: MOUNTING BRACKET

Process Sheet

: CU-DAR001 Dart Helicopters Services

Drawing Number : D2523 REV A2

DART AEROSPACE LTD	Work Order:	26940
Description: Mounting Bracket	Part Number:	D2523
Inspection Dwg: D2523 Rev: A2		Page 1 of 1

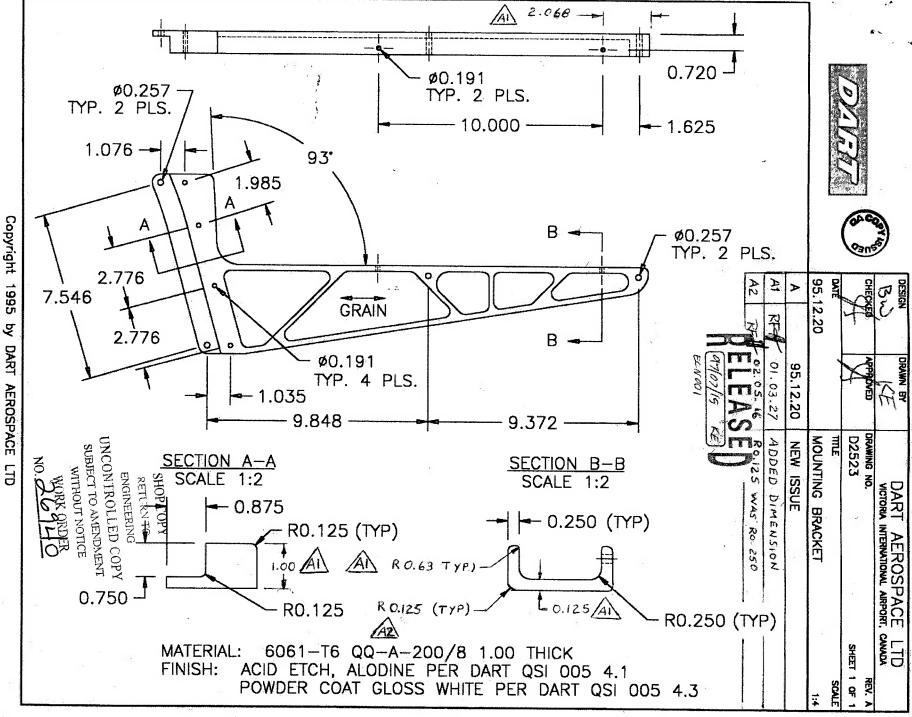
The material used for this piece is 1.016". The nominal dimension is 1.000".

The deviations are noted on the drawing

1 pocket is 0.125 + 0.016 (0.141") deep instand of 0.125"

port is too thick

Is this deviation acceptable? Yes # 06.05.15
